ADDENDUM NO. 1

April 23, 2024

Whiteland Community High School Phase 2A
300 E. Main Street
Whiteland, IN 46184

This Addendum consists of Pages ADD 1-1 through ADD 1-2 and attached Specification Sections 01 21 00 – Revised Contract Allowances, Logistics Plan, Guideline Schedule, and Lancer Associates Architecture Addendum No. 1, dated April 23, 2024, consisting of 63 Pages, Specification Sections 11 68 33 – Field Events & Athletic Equipment, 32 18 23 – Track Surfacing Latex System, 32 31 13 – Chain Link Fencing and Gates, 33 14 17 – Site Water Utility Service Laterals, 33 42 00 – Stormwater Conveyance, and Drawings 100, 210, 302, 303, 400, 401, 402, 403, 500, 501, 600, 601, 700, 900, 901, 902, 903, 904, 1004, L101, L102, L201, L202, L402, ES102, ES103, and ES301.

SITE MATERIALS PLAN -
PHASE 2A

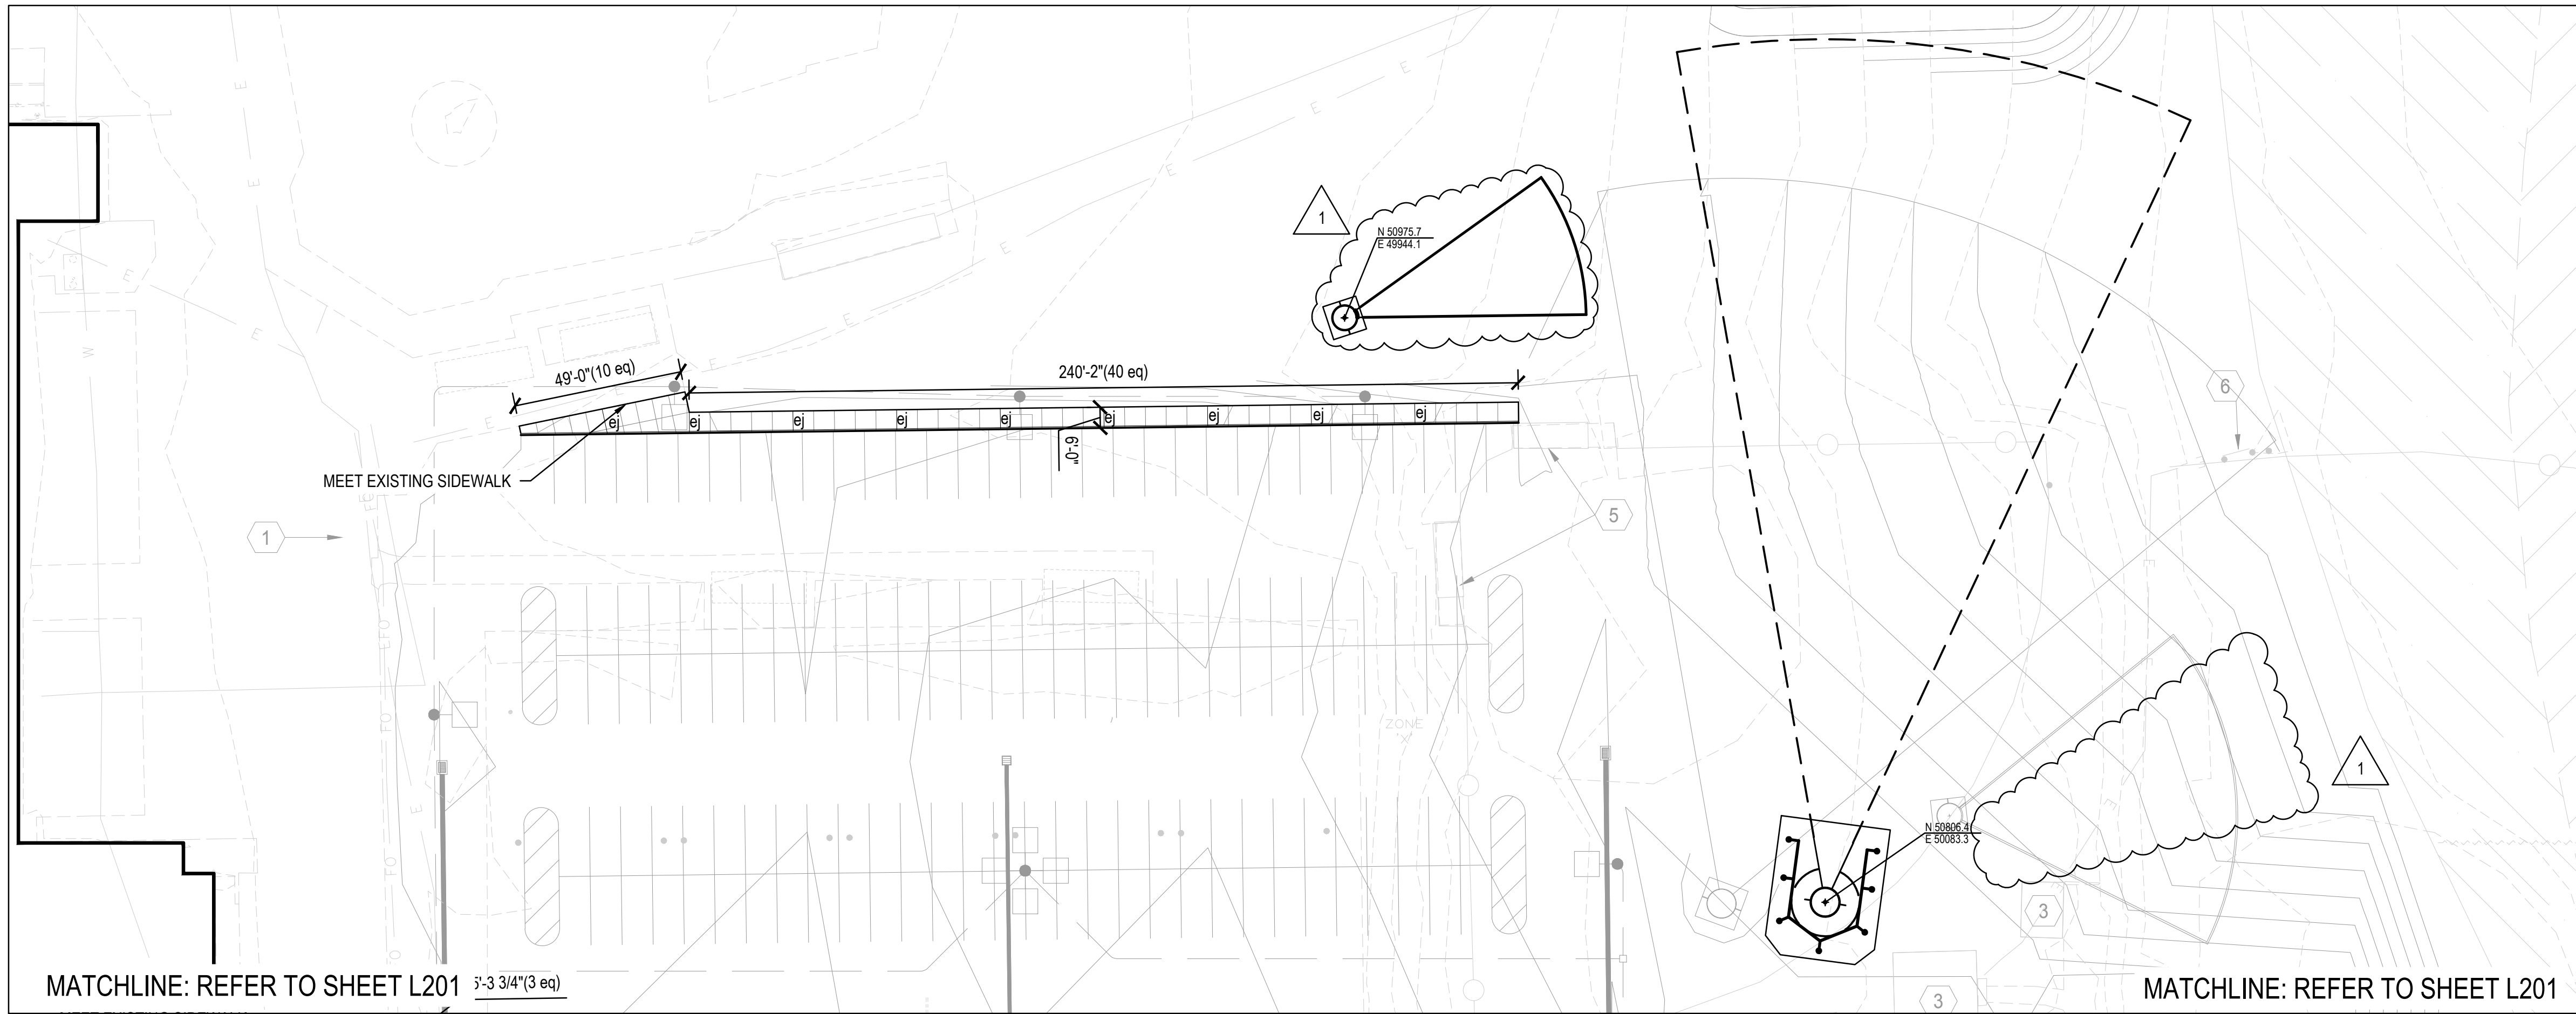
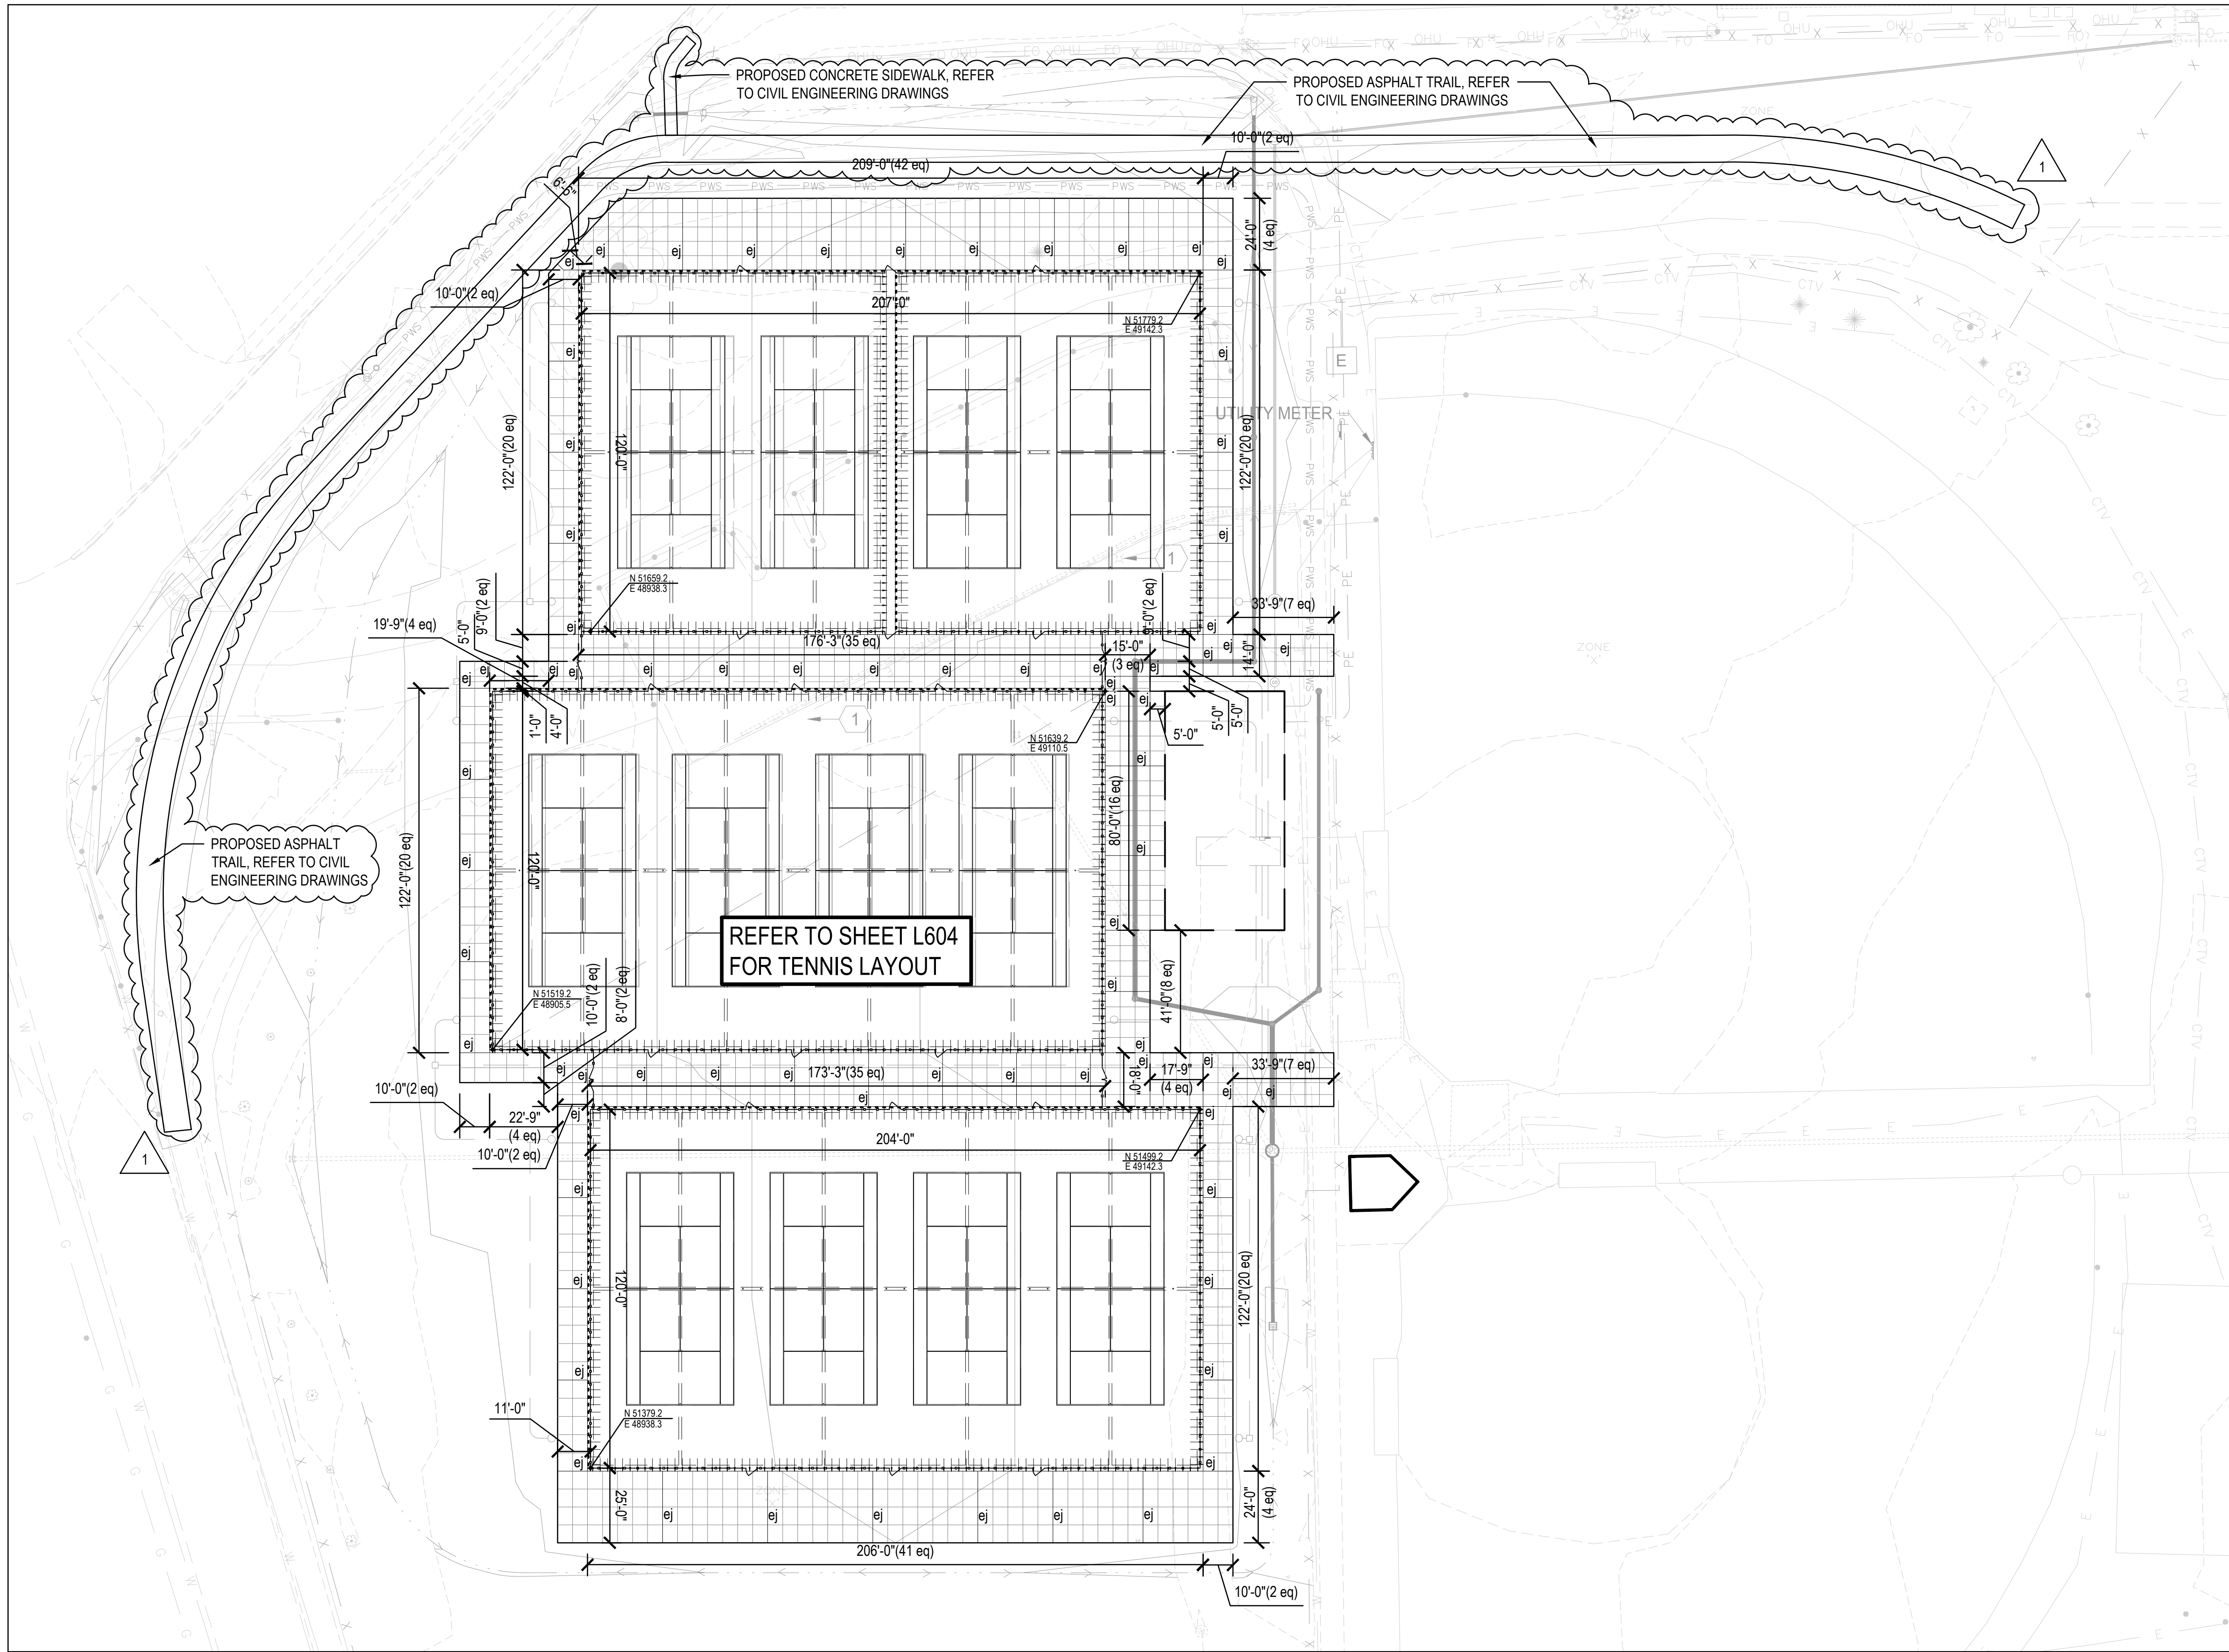
- o Updated to clarify fencing and gates around tennis courts.
- o Shot put ring and sector relocated.
- o Legend updated to clarify fencing and gates.

- Plan updated to show asphalt trail by tennis.
